SUBJECT: Bulletin "C" Dated May 7, 2020
PROJECT #: A1310-00
DESCRIPTION: Restoration Upgrades to Exterior Building Envelope
State Office Building - 135 Hanover Street
Trenton, Mercer County, NJ

PROJECT#: A1310-00 Restoration Upgrades to Exterior Building Envelope
State Office Building
135 West Hanover Street,
Trenton, Mercer County, N.J.

BULLETIN “C”

Sheet No.
D100
Sheet 3 of 20
©Lammy + Giorgio 2019

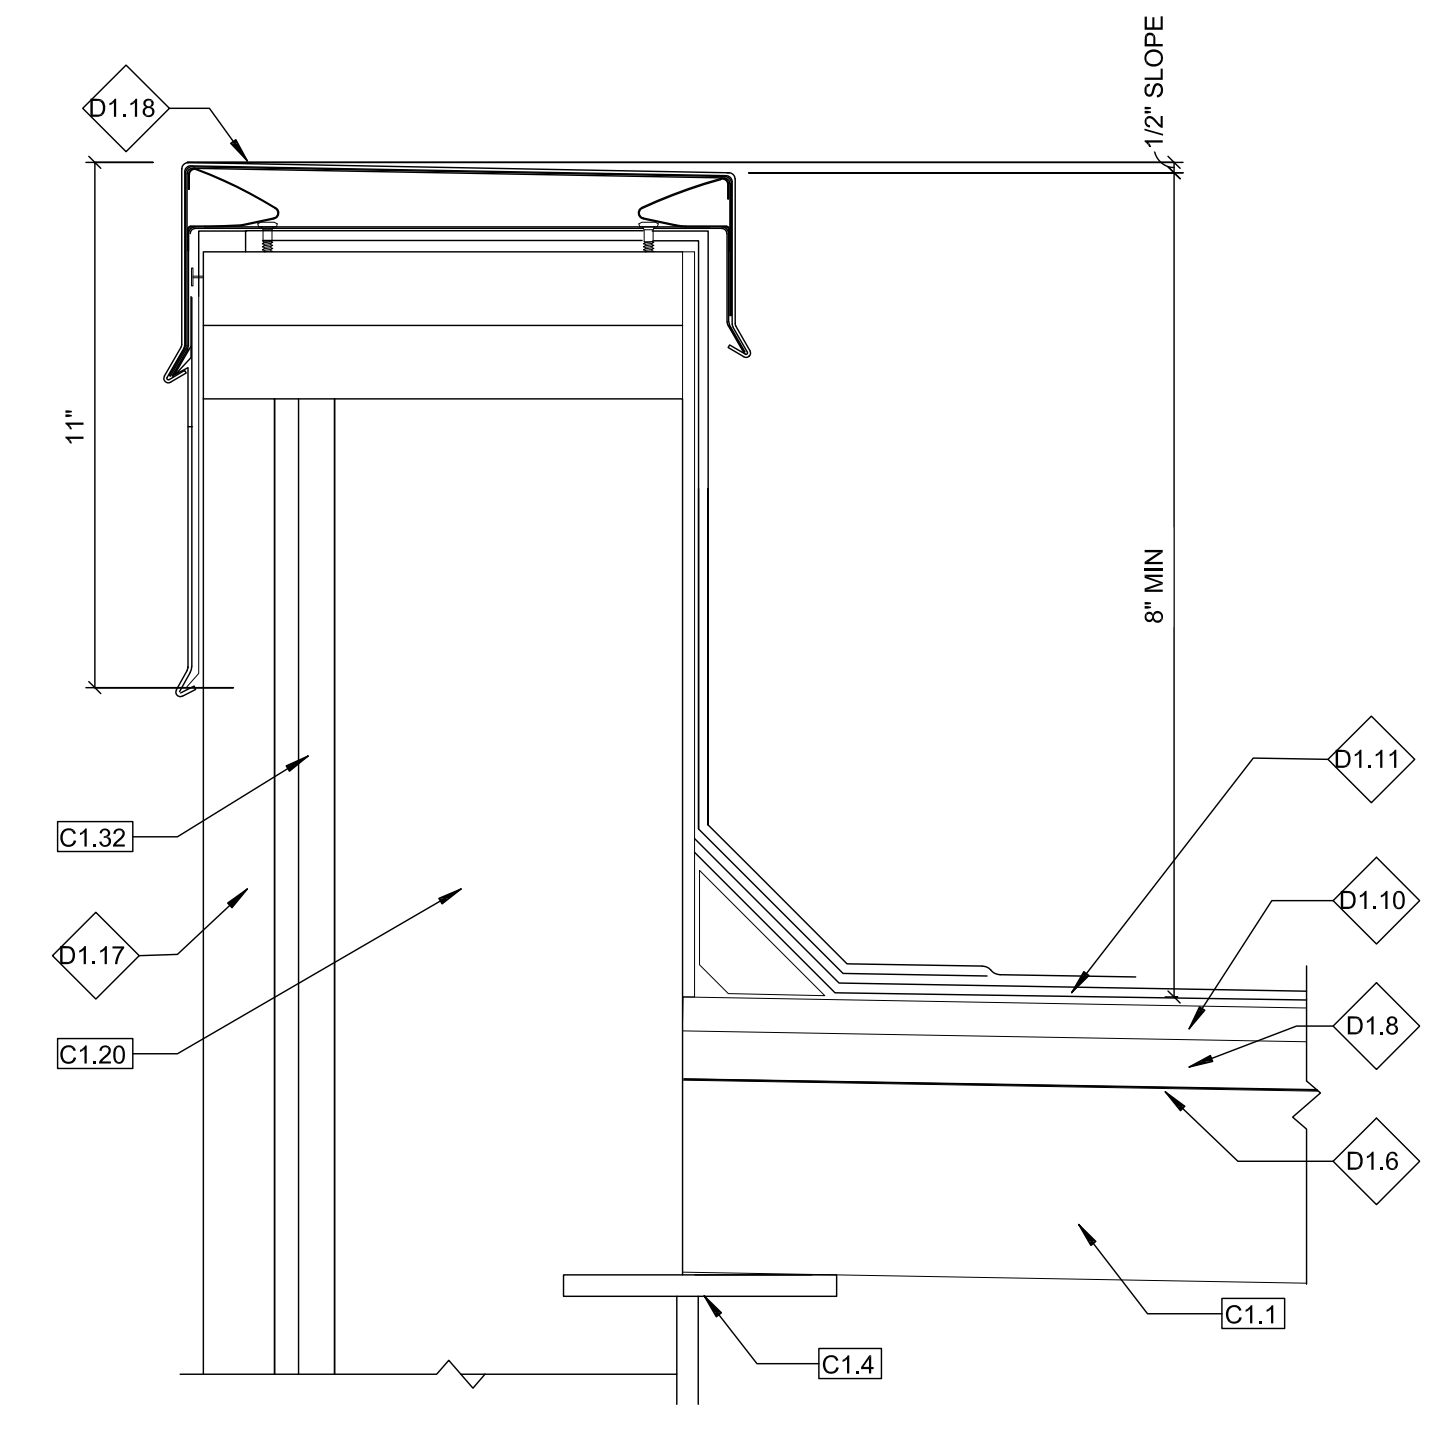
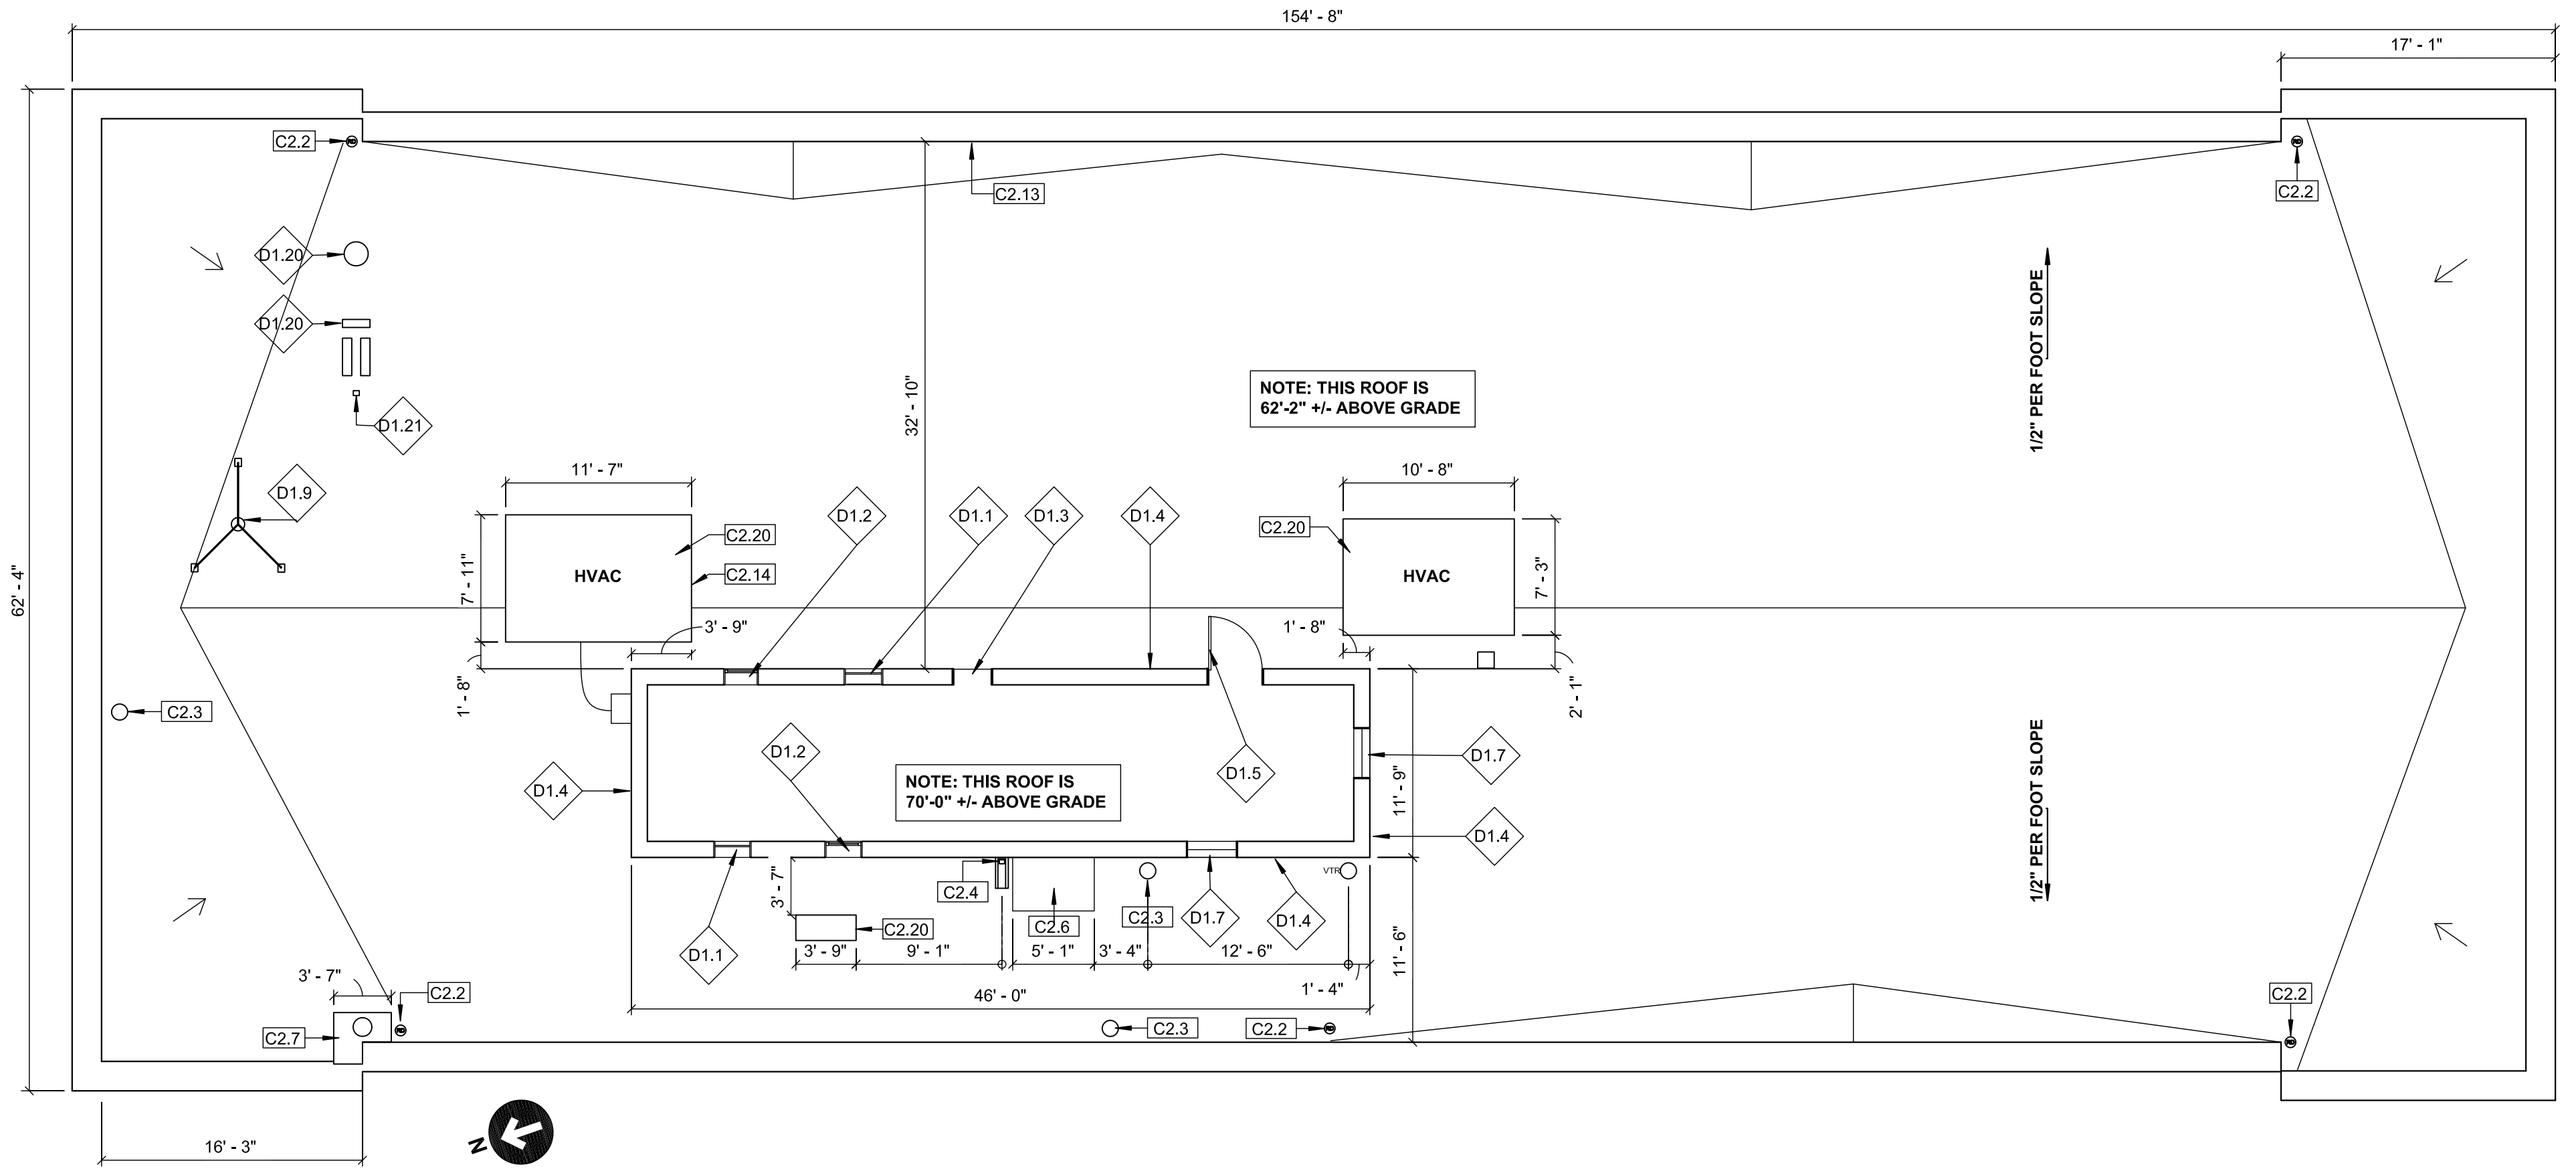
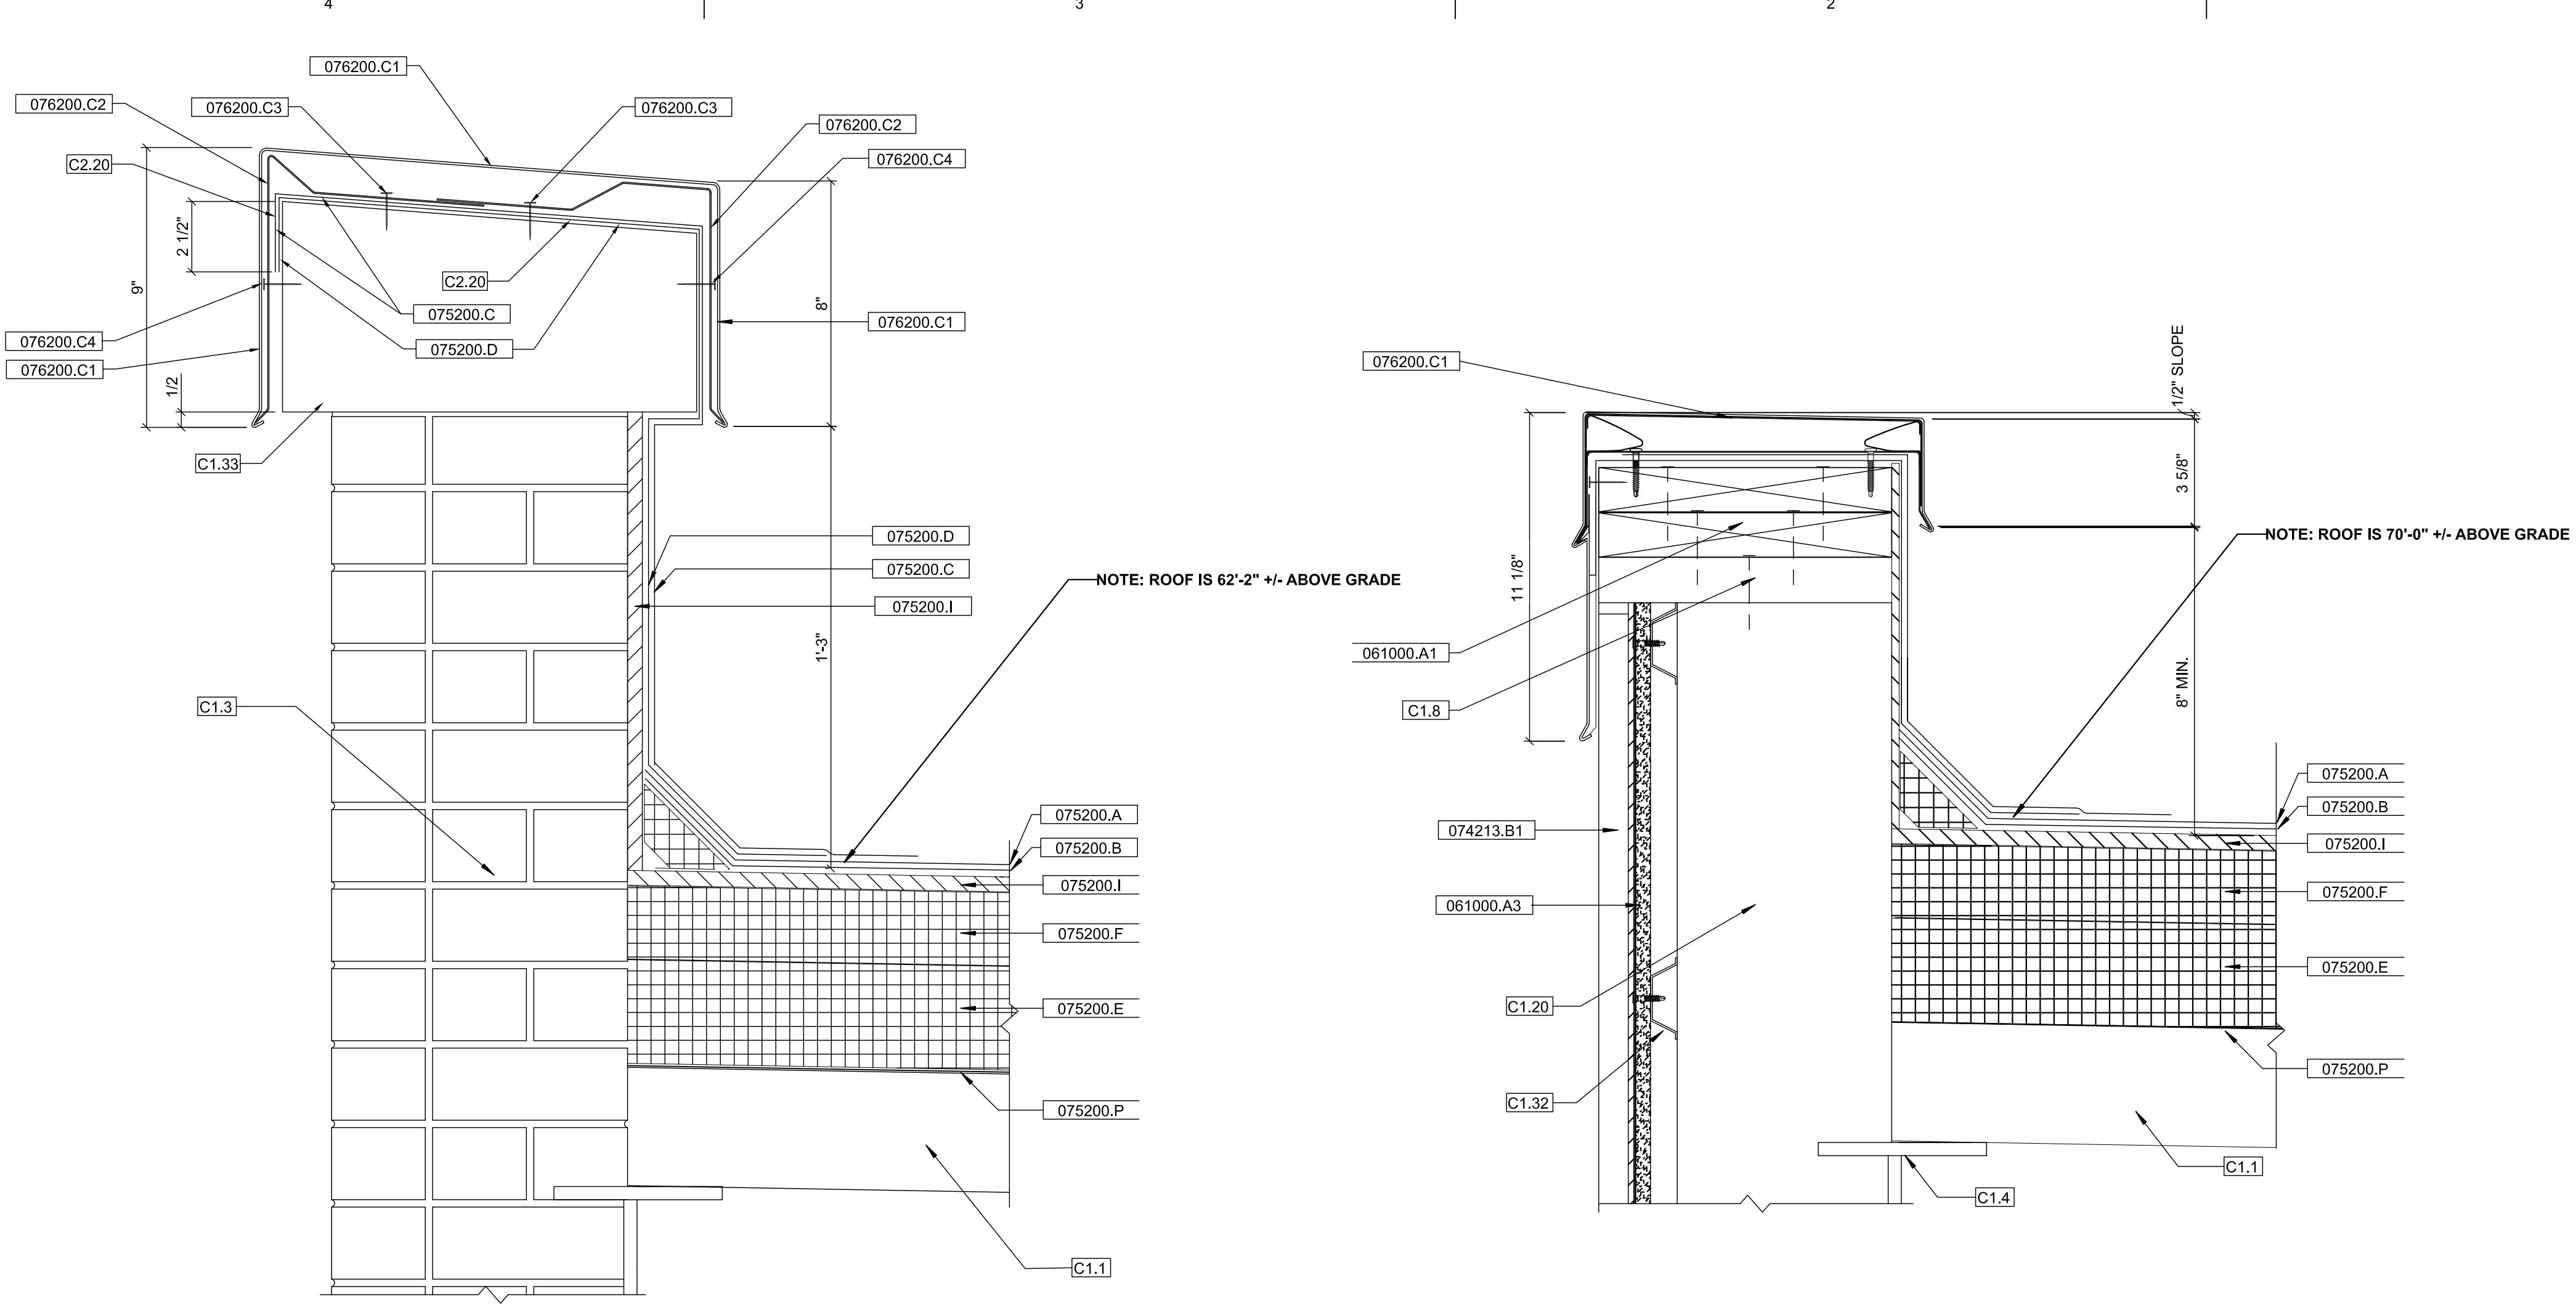
1. Delete all reference to removal of existing coping.
2. Drawing Sheet D100, delete in its entirety and replace with attached “Revised Drawing D100”.
3. Drawing Sheet A100, delete in its entirety and replace with attached “Revised Drawing A100”. Refer to Detail 1/A100.
4. Drawing Sheet A103, delete in its entirety and replace with attached “Revised Drawings sheet A103”. Refer to revisions to Window Types.
5. Drawing Sheet A200, delete in its entirety and replace with attached “Revised Drawings sheet A200”. Refer to revised Window Types.
6. Drawing Sheet A201, delete in its entirety and replace with attached “Revised Drawings sheet A201”. Refer to revised Window Types.
7. Delete all reference to Window Type ‘C’ from the drawings

7. Does the coping removal apply to all elevations? The structural drawings show the coping to be pointed/caulked.

RESPONSE: The coping will be pointed and caulked as shown on the structural drawings and then wrapped with new aluminum coping. See attached "Revised Drawing Sheet D100" and "Revised Drawing A100".
